BOARDS & COMMISSIONS APPLICATION

P24-03
Acme Final Site Plan - REVISION

Property Owner: Albrecht Incorporated
Applicant: Greg Ernst
Location: Northwest Corner of Wooster Pike and High Point Drive (Parcel #028-19C-20-153)
Zoning: SPD-1 (Special Planning District) with Underlying C-3 (General Commercial)
Request: Final Site Plan revision approval for a grocery store with a pharmacy drive through

**Revised
Landscaping Plan
Received 3/14/24**

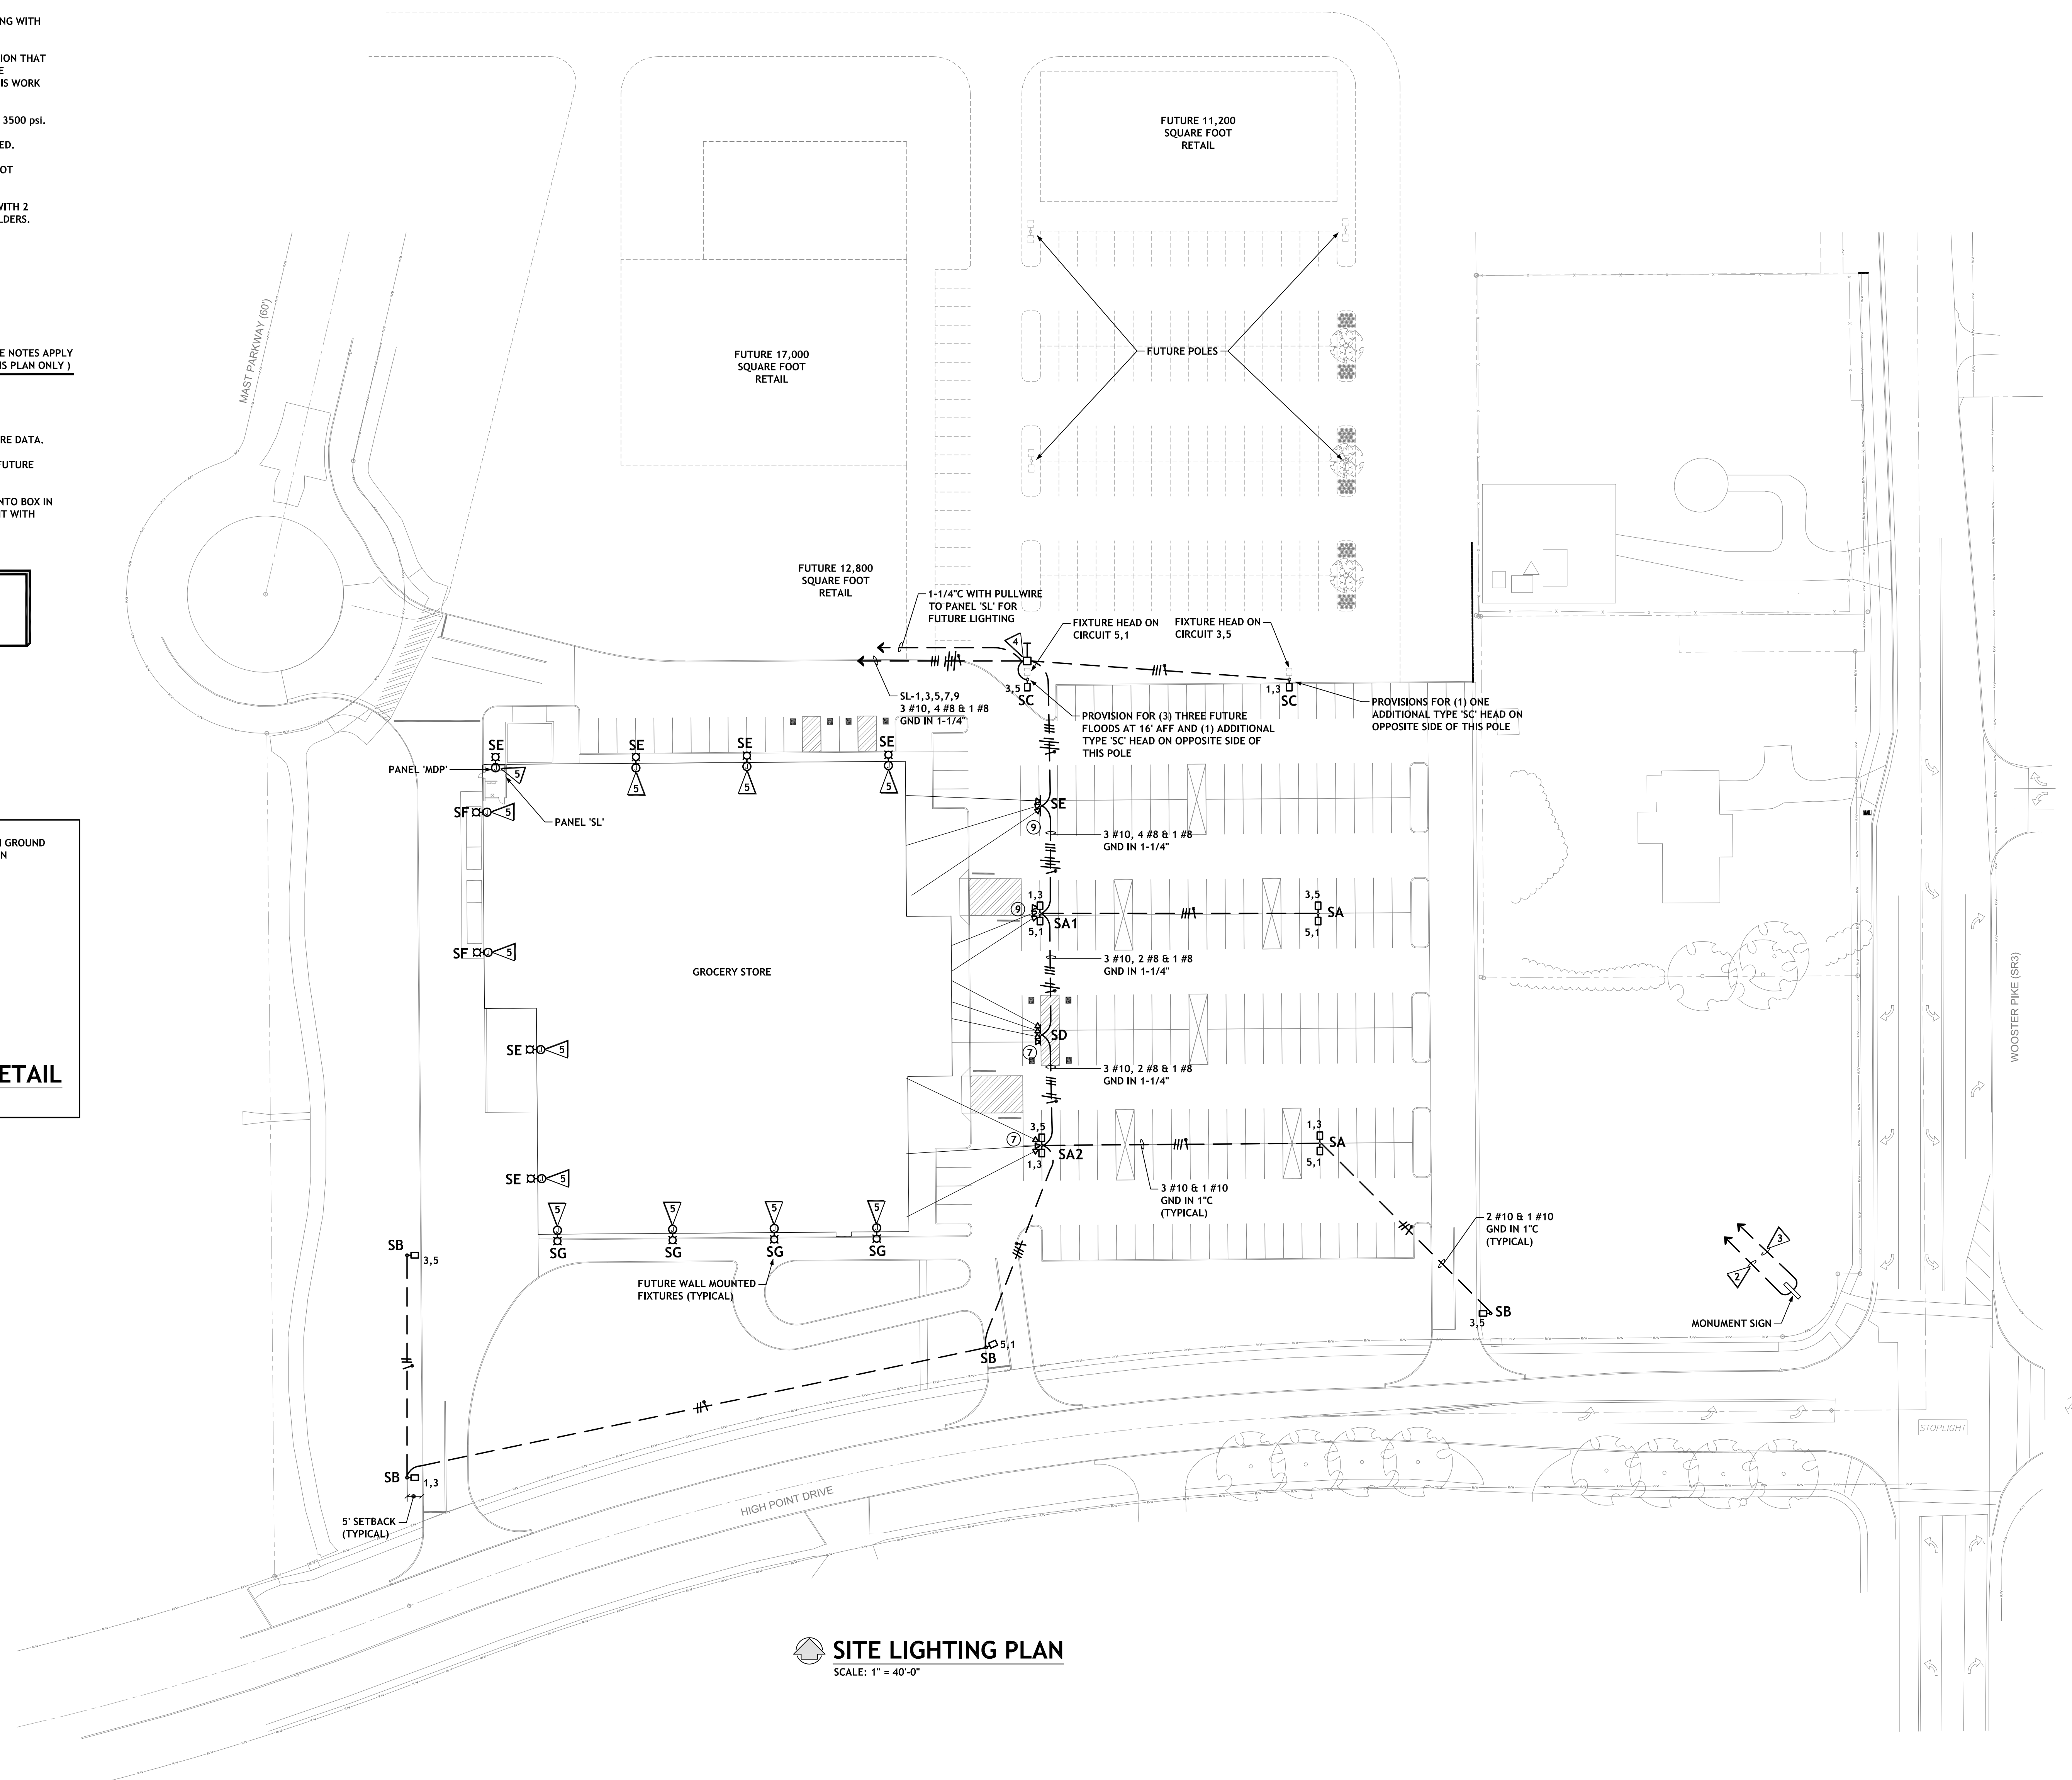
The Landscape Plan shows landscaping islands within the parking lot every 22 spaces, or less. In addition, landscaping is provided between the parking lot and High Point Drive. The proposed shift results in the removal of one landscape island in the northeast corner of the site.

Buffering and Screening – A 75 ft. landscaped buffer yard is required along the west side of the building at 6 ft. in height to provide a buffer from Subdistrict “C” to the west. Such a buffer is shown along the west side of the building.
